Bethesda Downtown Design Advisory Panel

Project Name	8280 Wisconsin Avenue
File Number(s)	Site Plan No. 820180230 and Preliminary Plan No. 120180280
Project Address	8280 Wisconsin Avenue

**8280 Wisconsin Avenue
Site Plan – Design Advisory Panel Submittal**

WISCONSIN AVE VIEW

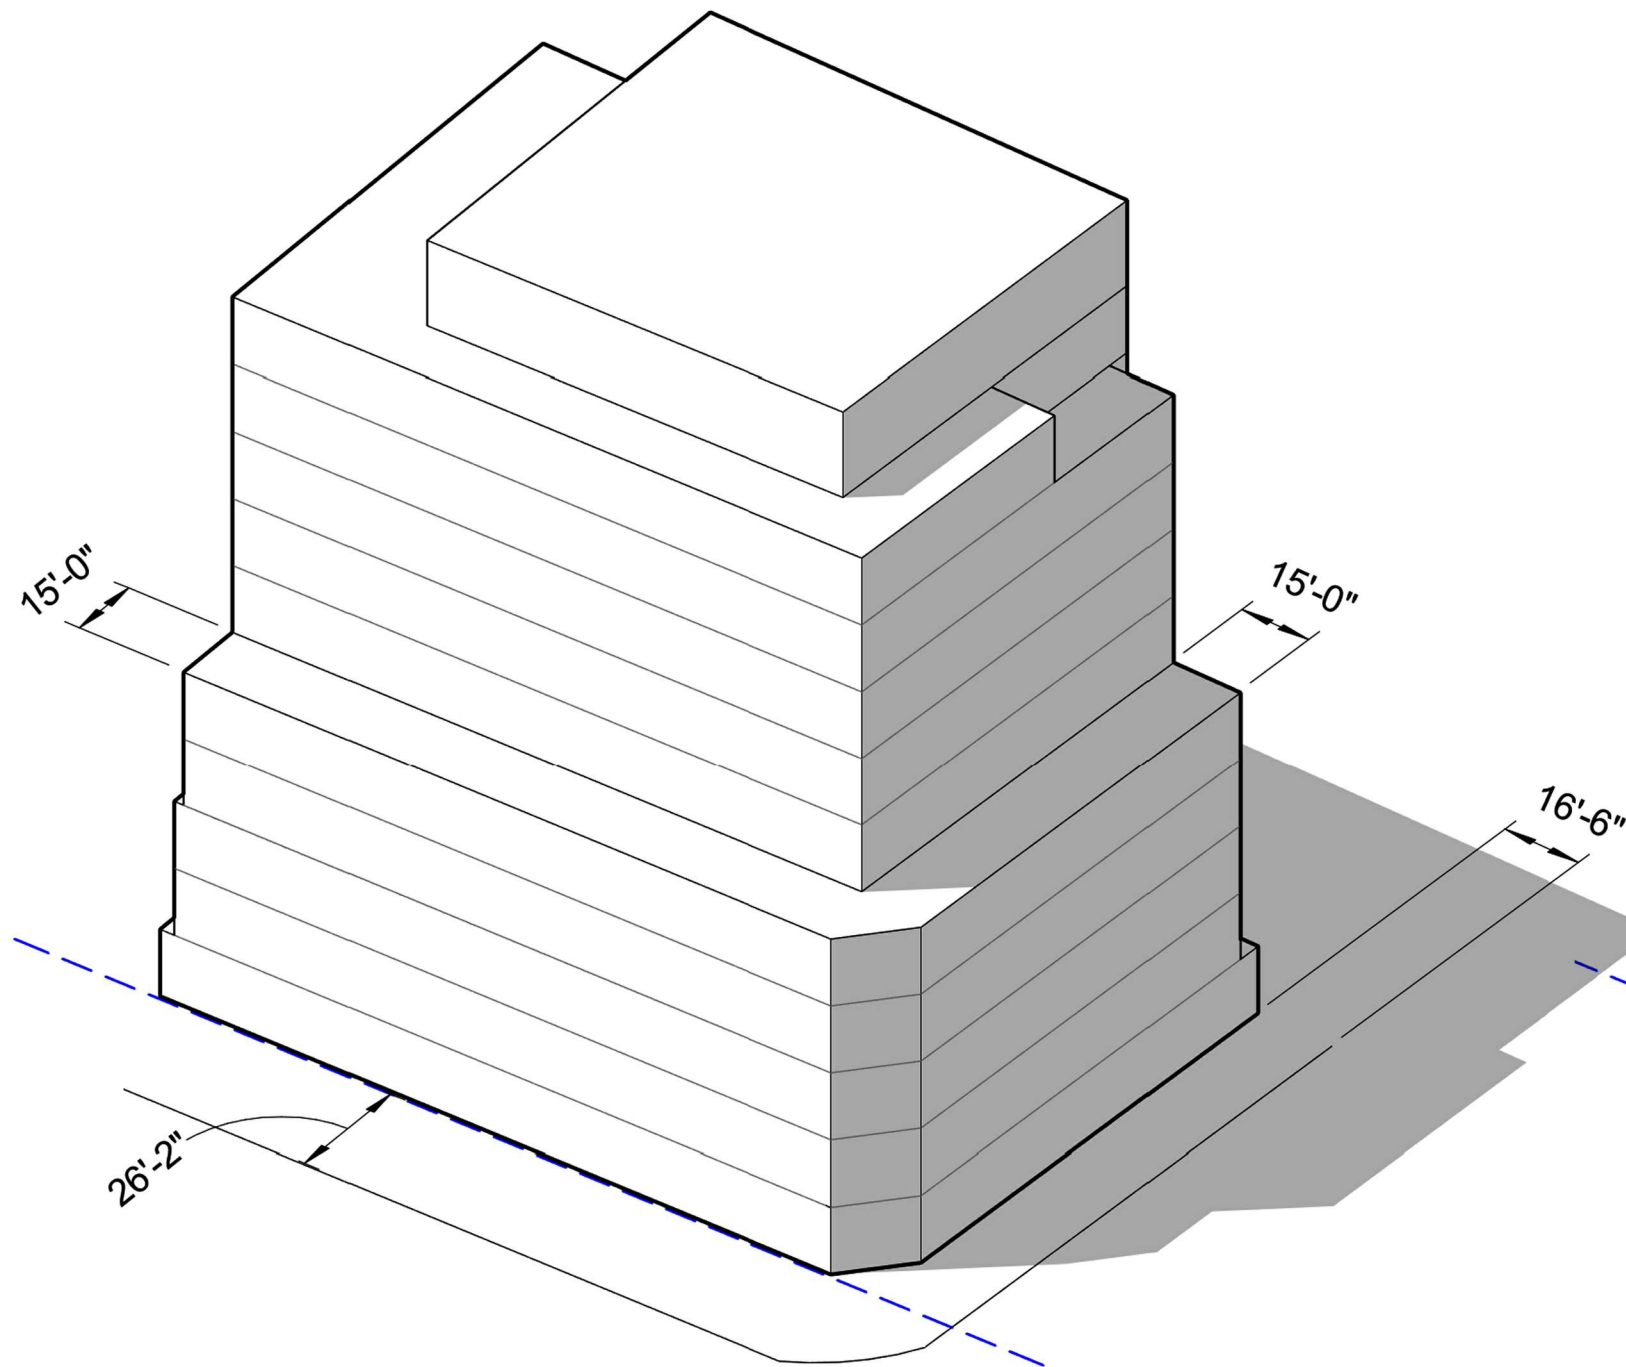
M-NCPPC Professional Staff Comment 1. The sculptural corner of the façade on Wisconsin Avenue is essential to the design of the project, but explore minor design changes to the southern portion of the Wisconsin Avenue façade.

- 1) Study the articulation of the south end of the west facade to break it from the full length of Wisconsin Ave.
- 2) Study lengthening the amount of glass at the north end of the western facade.

Response: While the DAP did not express concerns relating to the Wisconsin Avenue façade of the Proposed Project, Staff raised some concerns about providing some “relief” along the middle portion of the Wisconsin Avenue façade. The suggestion was to provide more visual interest and aesthetic relief to the important frontage of the Proposed Project along Wisconsin Avenue. In response, and as reflected on the graphic elevation labeled “SE CORNER TREATMENT” within the DAP submission, the Applicant proposes to angle the façade back into the building at the southern end along floors 3 thru 5. The diagonal deflection mimics the major chamfered vertical expression at the NE corner of the building. This architectural feature will break up the continuous glazing along Wisconsin Avenue and provide for a more graceful transition to the northern façade.

SITE PLAN

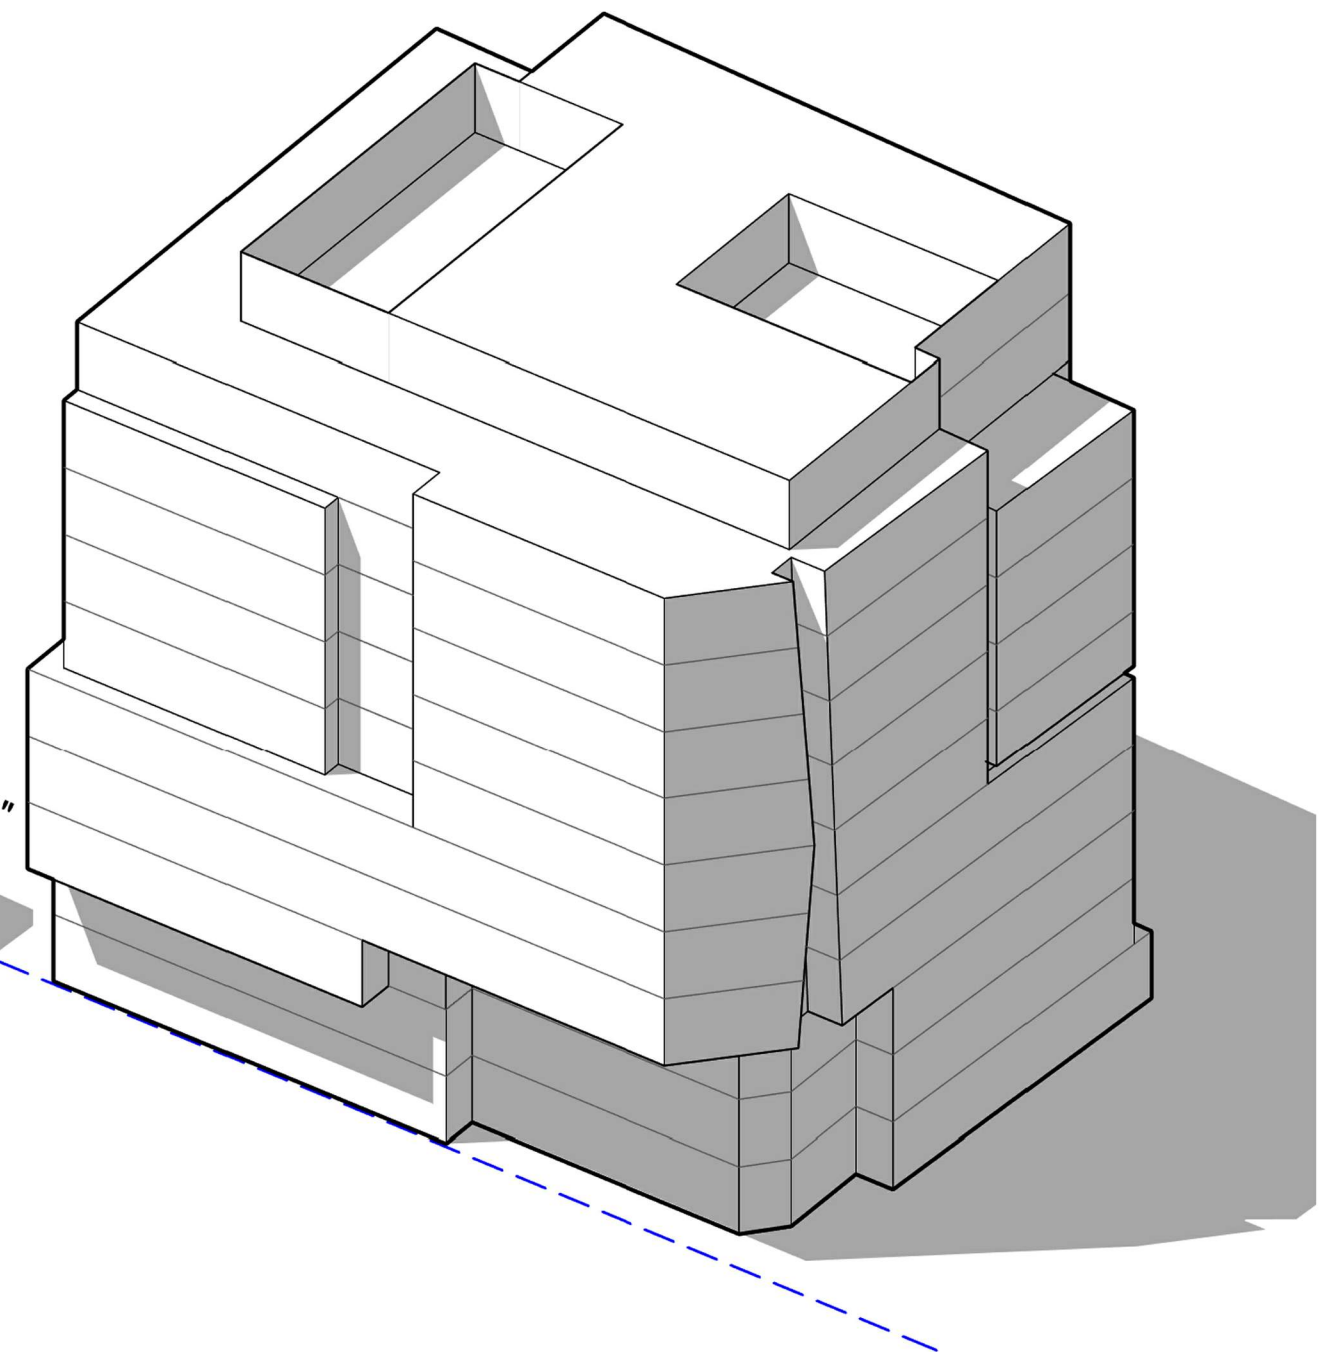
DAP Recommendation 1. Provide a landscaping plan showing the design of the public realm and the enhanced tree canopy along Battery Lane, a canopy corridor.

Response: The Applicant has modified the streetscape illustrated on the Sketch Plan to enhance the public realm on Battery Lane in a number of ways. Utilities that were previously proposed on Battery Lane and that were presenting significant issues in terms of allowing for meaningful streetscape/landscape have been relocated to Wisconsin Avenue to allow for a wider accessible pathway on Battery Lane than that previously allowed. The updated landscape plan

also reflects two street trees along Battery Lane in accordance with Section 2.1.10 of the Design Guidelines (Canopy Corridors). A rendered landscape plan is included with this submittal, which demonstrates that this recommendation has been and will be satisfied with the proposed Site Plan.

STRICT INTERPRETATION OF THE DESIGN GUIDELINES

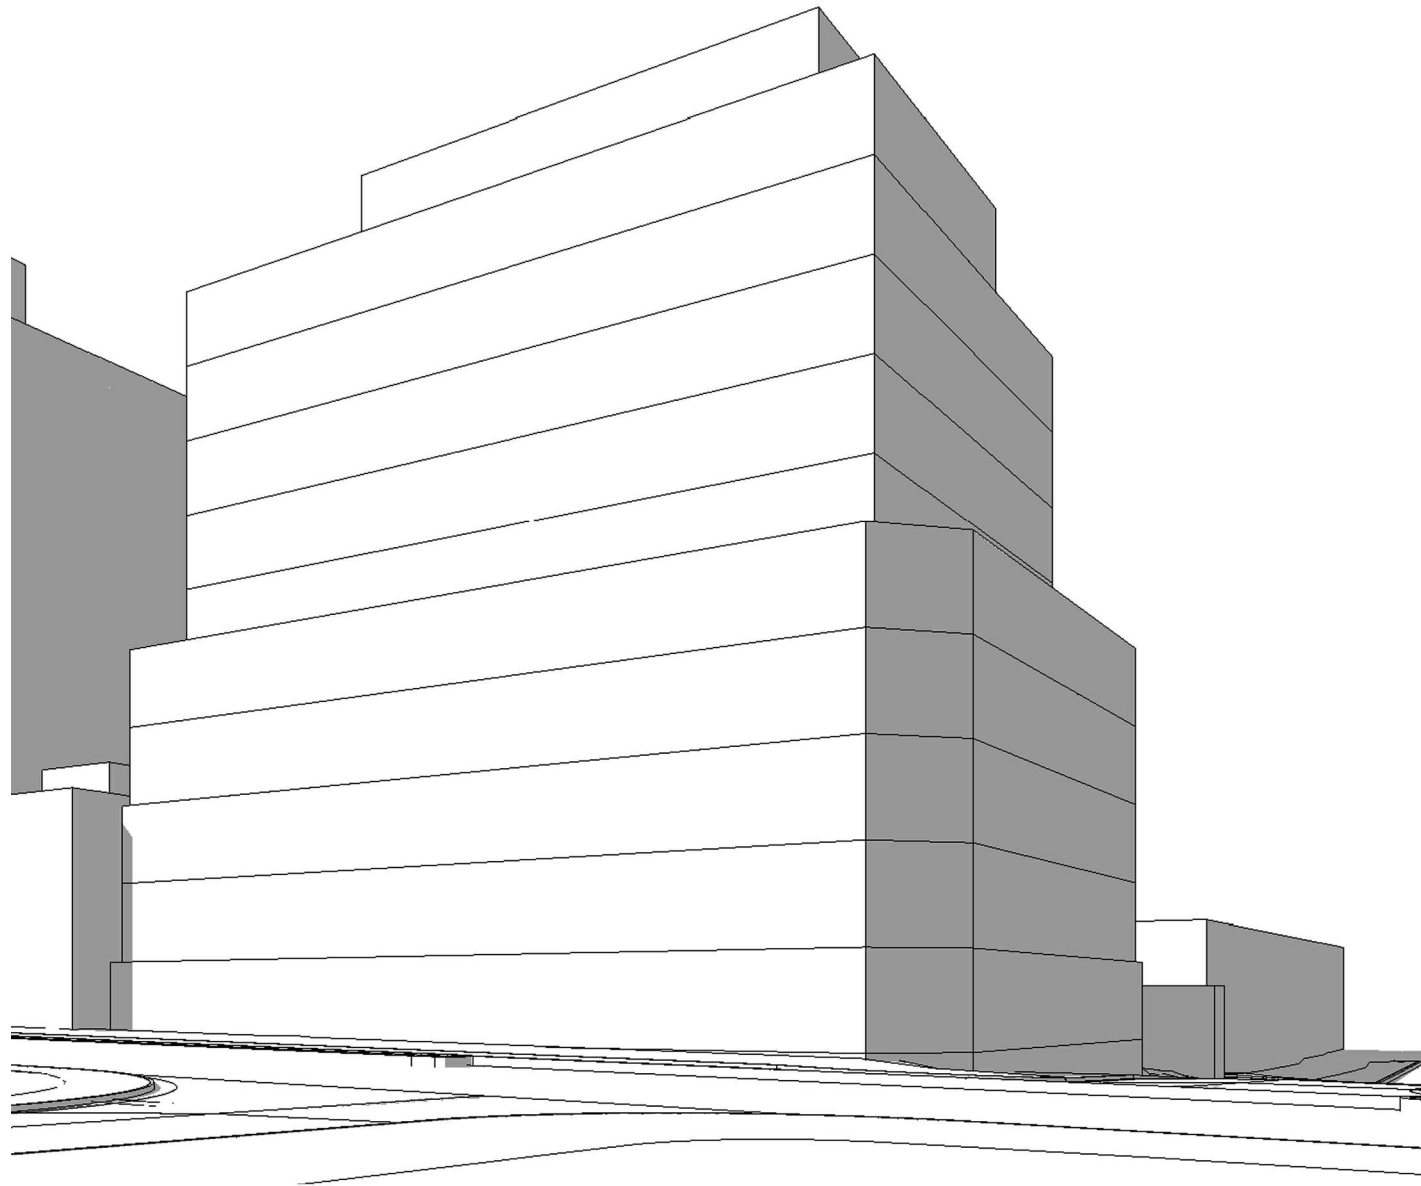
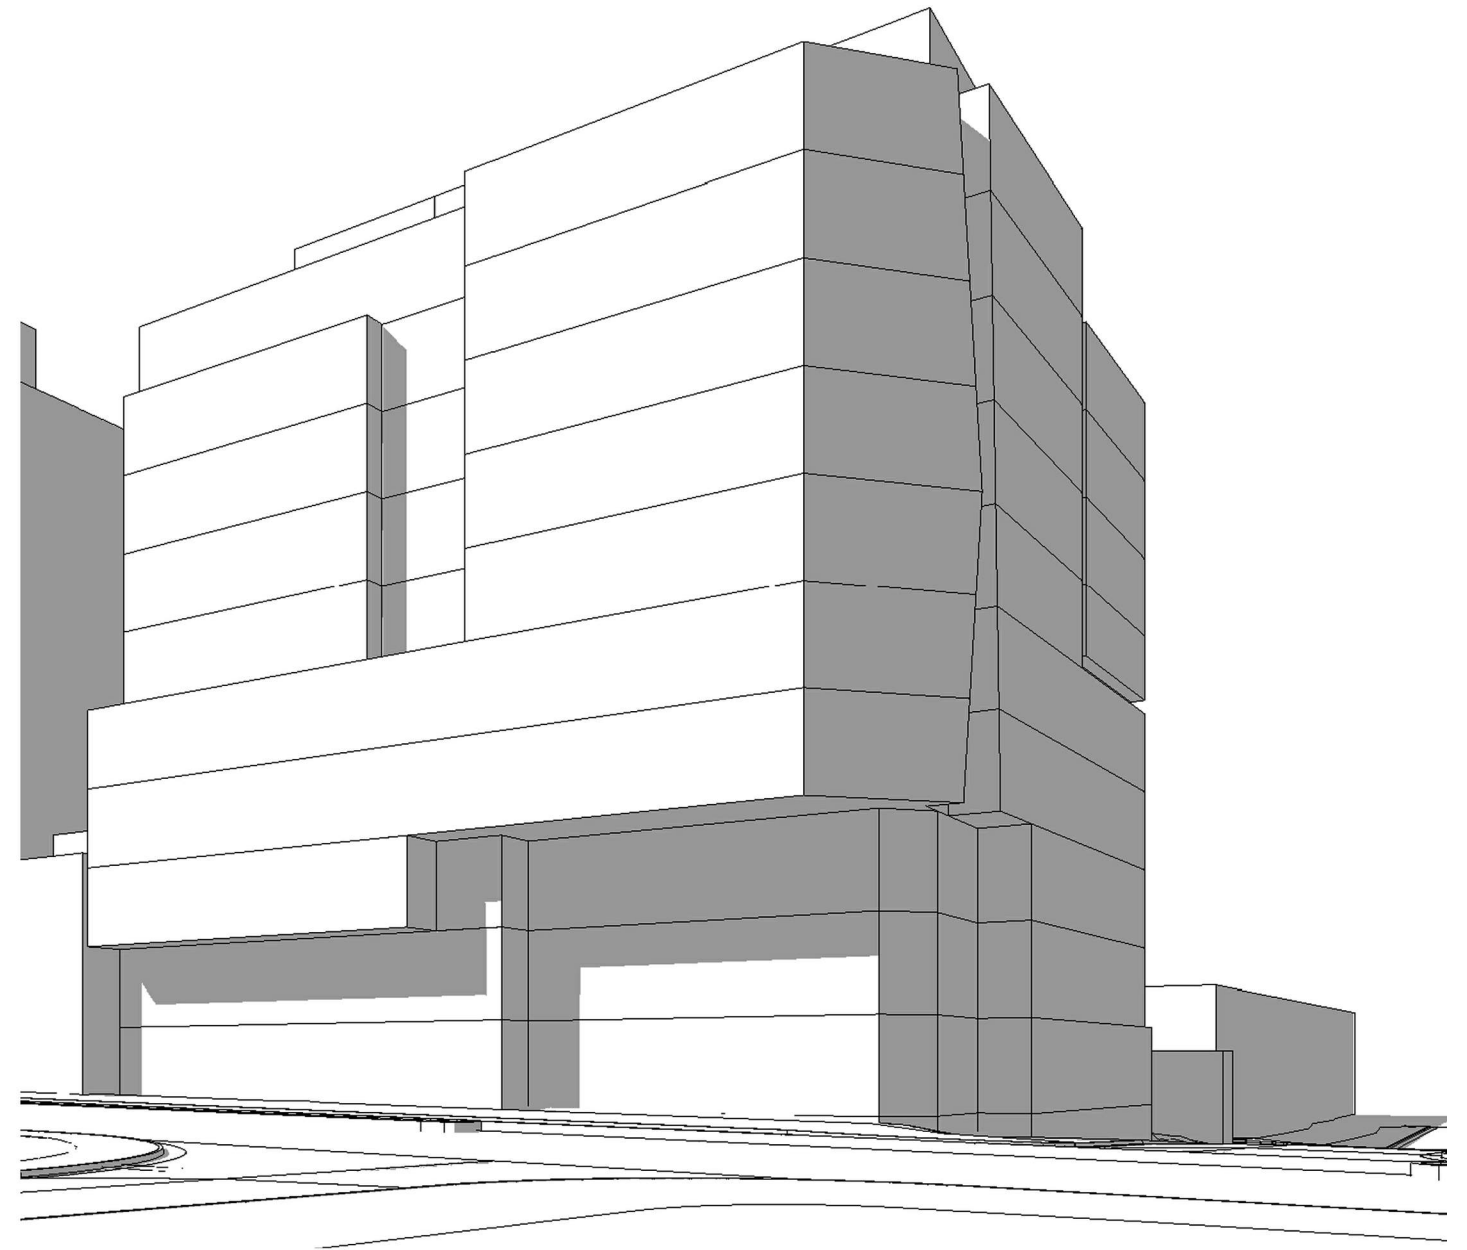
DAP Recommendation 2. Provide a diagram that illustrates what a strict interpretation of the guidelines would bring and why the applicant is proposing a departure. Particularly from the step-back guidelines.

Response: A massing diagram that shows what a strict interpretation of the Design Guidelines would allow for at this corner lot with limited size and property depth is included with this submittal labeled on the bottom of the graphic as “Strict Interpretation of the Design Guidelines.” The strict interpretation massing diagram reflects full tower step-backs along Wisconsin Avenue and Battery Lane of 15 feet. Strict adherence to the tower step-back recommendations in the Design Guidelines would not allow for an economically viable floor-plate for bio-science lab uses. (At the time of Sketch Plan, the Applicant discussed that the Proposed Project was intended to specifically draw bio-lab and bio-science tenants to not only the Property, but also potentially to create a bio-science cluster for this part of Downtown Bethesda. The Proposed Project embraces the opportunities provided for with NIH and related bio-research governmental agencies, programs, and ancillary uses and facilities in an urban design not available elsewhere in the region – looking to bring the success of areas such as Cambridge Massachusetts to Bethesda and Montgomery County). The Applicant suggests that the alternative methods provided in the Design Guidelines recognized that certain types of development and redevelopment such as the Proposed Project. Thus, alternative ways of achieving the goals and objectives provided in the Design Guidelines is both necessary and appropriate to attract this use to the Property and area.

The Applicant is proposing a departure from Section 2.4.7 of the Design Guidelines (Tower step-back) for two reasons. First, the departure from the Design Guidelines is necessary for the Proposed Project to incorporate a corner treatment that will function as a sculptural point of interest at this gateway site along the northern section of the Wisconsin Avenue Corridor. The departure is consistent with the Design Guidelines recognition that the Planning Board may approve alternative design approaches that truly achieve exceptional and unexpected creative solutions that improve the Downtown. Thus, the departure from the tower step-back recommendations will allow for a signature design element on the prominent corner of Battery Lane and Wisconsin Avenue. Second, Section 2.4.7 of the Design Guidelines recognizes that there are alternative methods to reducing bulk on sites with limited size or property depth from the street. The Property lacks the size and depth from Wisconsin Avenue to allow the Proposed Project to literally incorporate the setbacks and step backs provided for in the Design Guidelines and as such the alternative design is justified. The Applicant has also included two separate

diagrams which annotate and demonstrate how this alternative design meets the spirit and intent of the Design Guidelines. *See Sheets 6 and 7 of the DAP submittal.*
